Access Compliance Report

Public Rights-of-Way

(Curb Ramps)

Intersection ID: 18738	Main Street: FERNCLIFF_RD	Cross Street: SHARON_RD	Location: SW
ADA ID: 044B56B4738A	Ramp Type: PerpDiag	Initial Pass/Fail: Fail	Overall Compliance: No
Codes/Mitigation Info/Possible Solution		Field Measurements/Component Compliance	
Severity Score: 33.75

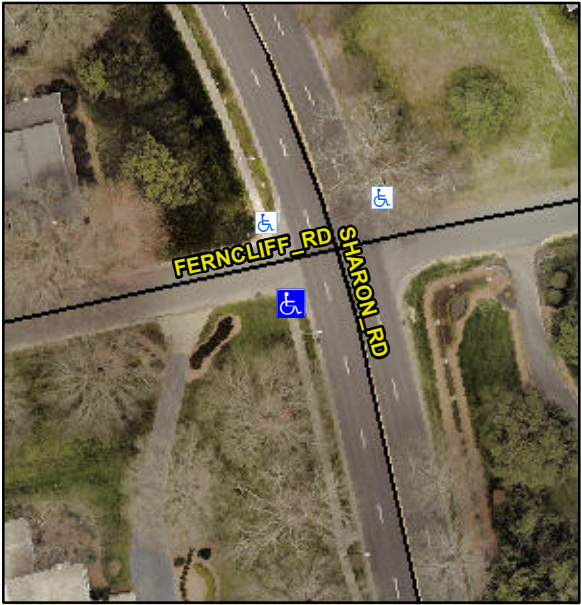
Possible Solutions:	Compliance	Description	Data	Compliance	Description	Data
	Remove & Replace Curb Ramp With Two New Directional Ramps or Equivalent.	N/A	Ramp Length (in)	56.0	No	Ramp Slope (%)	13.0
<p>Surveyor Notes:</p> <p>N/A</p> <p>PROW/ADA:</p> <p>Not Found, R304.5.1, R304.2.2</p>		No	Ramp Width (in)	47.0	Yes	Ramp XSlope (%)	1.0
		N/A	Flare Type LT	N/A	N/A	Flare Type RT	N/A
		N/A	Flare Slope LT (%)	N/A	N/A	Flare Slope RT (%)	N/A
		N/A	Flare Traversable LT?	N/A	N/A	Flare Traversable RT?	N/A
		N/A	Landing Length (in)	N/A	N/A	DWS Provided?	N/A
		N/A	Landing Width (in)	N/A	N/A	DWS Contrast?	N/A
		N/A	Landing Slope (%)	N/A	N/A	DWS Length (in)	N/A
		N/A	Landing X Slope (%)	N/A	N/A	DWS Full Width?	N/A
		N/A	Landing Curb? (Y/N)	N/A	N/A	DWS Offset (in)	N/A
		N/A	Shared Landing?	N/A			
		N/A	Gutter Ponding?	N/A	N/A	Gutter Slope (%)	N/A
		N/A	Gutter Lip Ht (in)	N/A	N/A	Gutter X Slope (%)	N/A
		N/A	Painted X Walk1?	No	N/A	Painted X Walk2?	No
